Big Darby Accord Advisory Panel

1. Roll Call
2. Introduction of Staff
3. Approval of [minutes from May 10, 2022](#)
4. New Business
 - a. **[Case AP-22-03](#)**
Review and action regarding a City of Hilliard application proposing a new Recreation & Wellness Center.
Applicant: *City of Hilliard*
Location: *City of Hilliard*
Address: *7380 Scioto Darby Rd.*
Acreage: +/- 166.42 acres
Zoning: *PUD, Planned Unit Development*
Request: *Development of a Recreation & Wellness Center on the south side of Scioto Darby Road & east of Alton Darby Road.*

Project Information
Project Name Hilliard Recreation & Wellness Center
Project location South side of Scioto Darby Road & East of Alton Darby Road
Checklist Completed by Drew Russell, PLA, EDGE Chad Boyer, PE, CFM, ms consultants, inc.

Staff Analysis

**Hilliard Wellness Campus/Clover Groff Phase 2 Restoration
Site Location within General Land Use Plan**

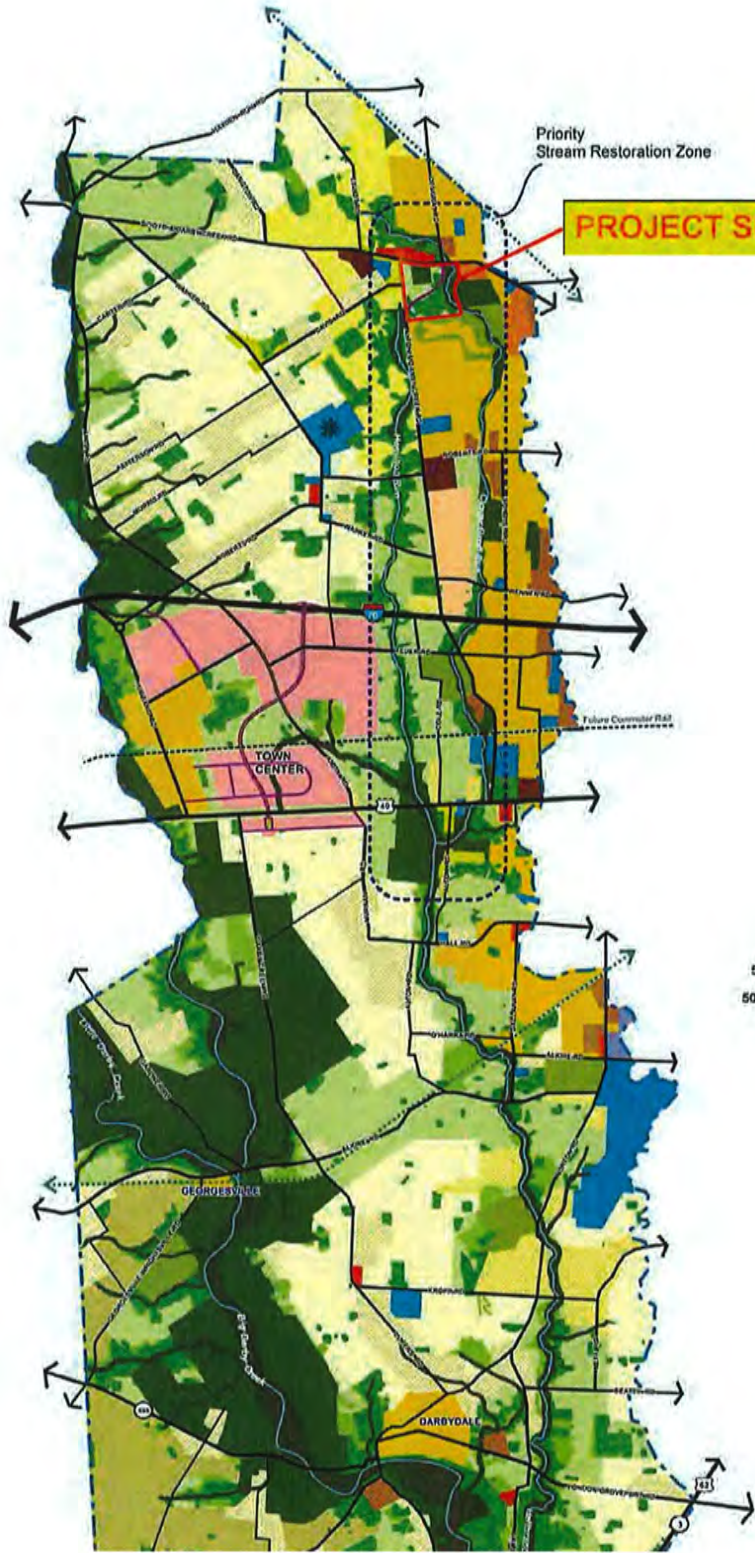
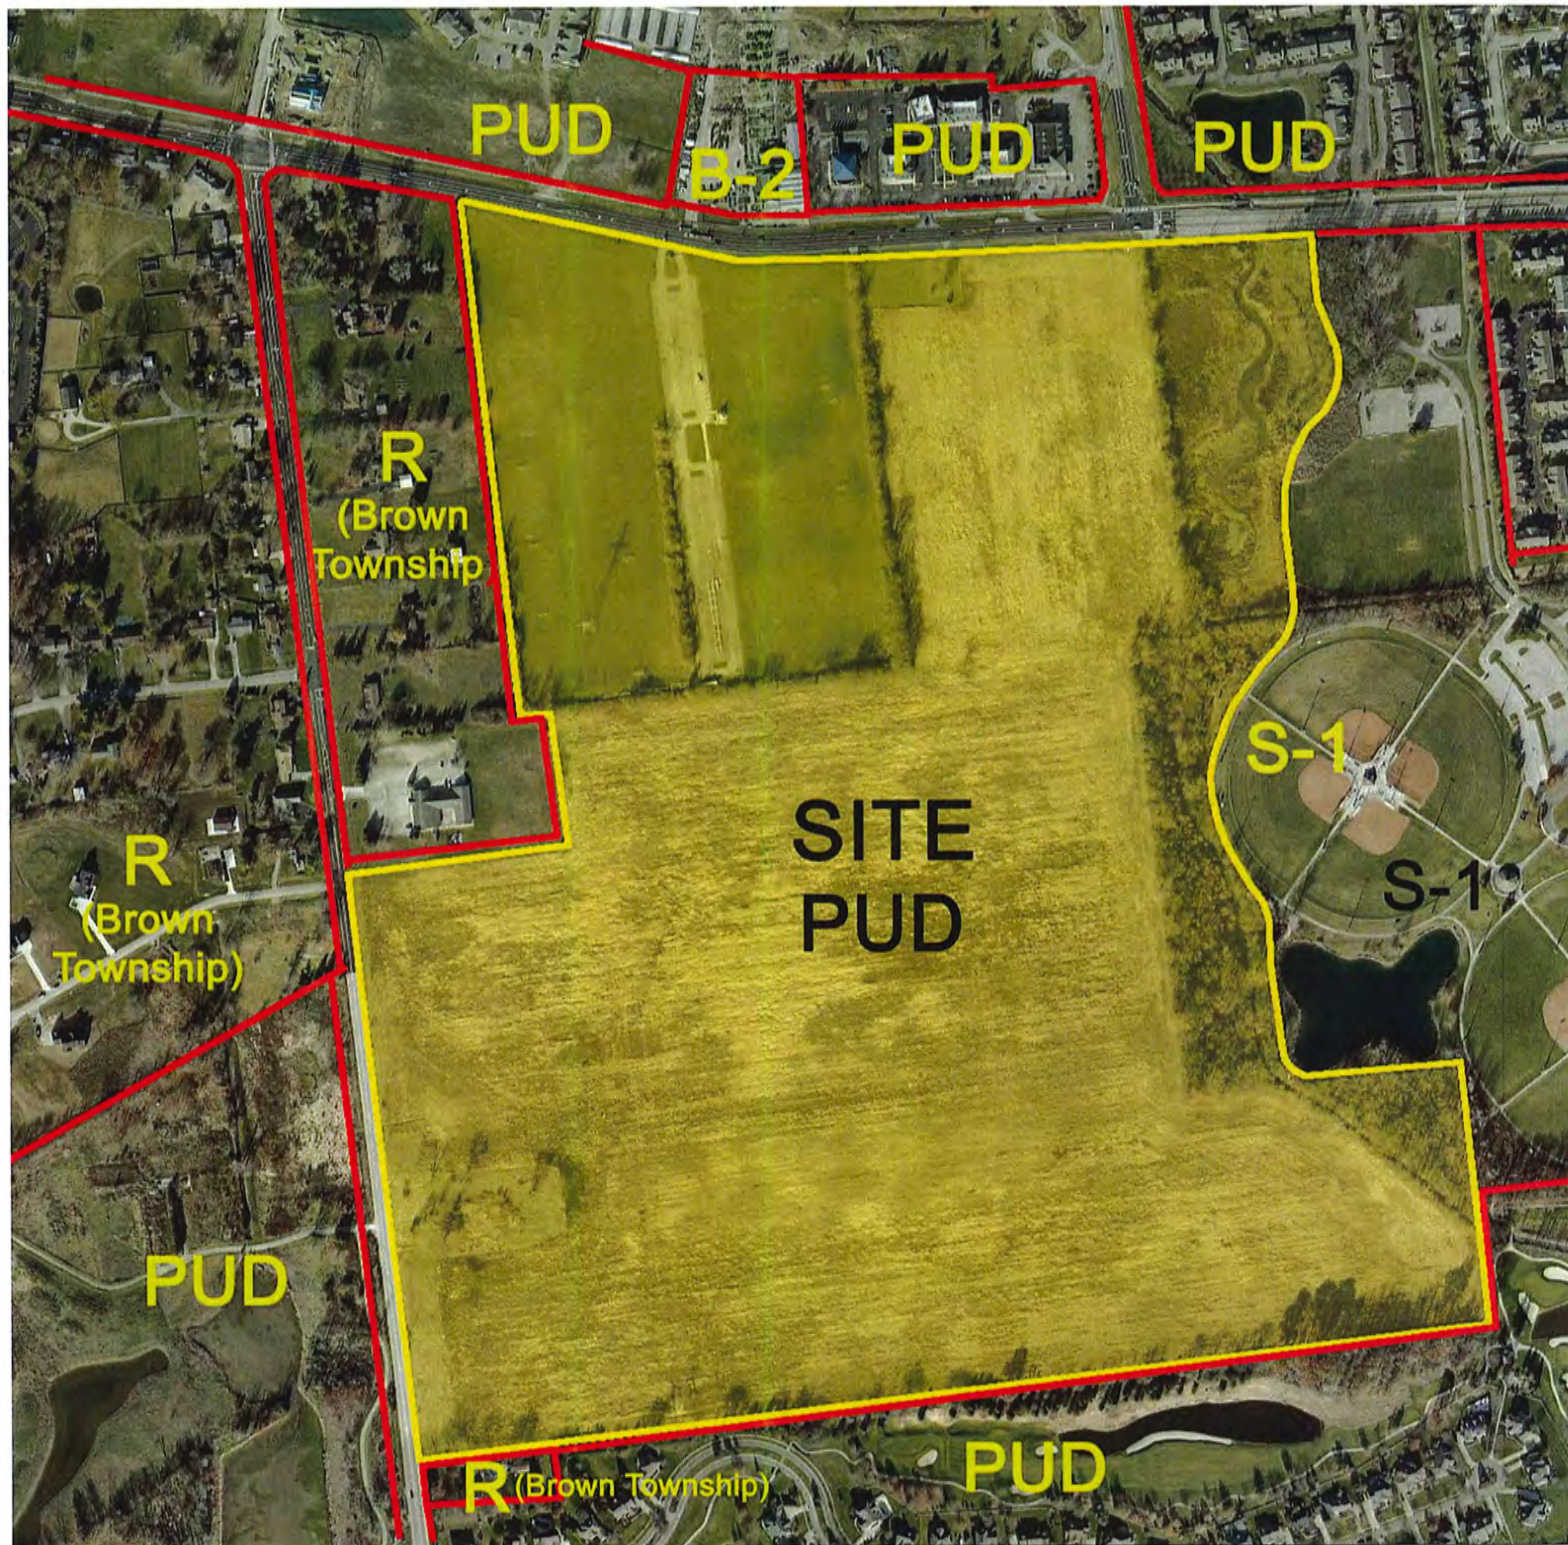
Figure 3.7 Proposed General Land Use Map identifies the site as Existing Parks and Easements, and Tier 1 and Tier 3 conservation zones. It should be noted that revised FEMA Flood Insurance Rate Map information demonstrates that a significant portion of the 100-year floodplain has been eliminated. Stream restoration activities will further reduce the amount of 100-year floodplain. The northern portion of the site is proposed to be developed with a recreation and wellness center, office uses, and athletic fields. This alternative land use will be mitigated on site by the stream restoration planned for Clover Groff Ditch and the proposed storm water management facilities including vegetated swales on each side of the Cosgray Road extension. The project will conserve at least 50 percent of the overall site as open space. The proposal will incorporate Low Impact Development principles to disconnect impervious areas, lengthen flow paths, and promote infiltration. The proposal includes the construction of the Cosgray Road extension through the site consistent with the Hilliard Thoroughfare Plan and the Big Darby Accord General Land Use Plan. The proposal will provide bike/pedestrian path links to adjacent properties and rights-of-way.
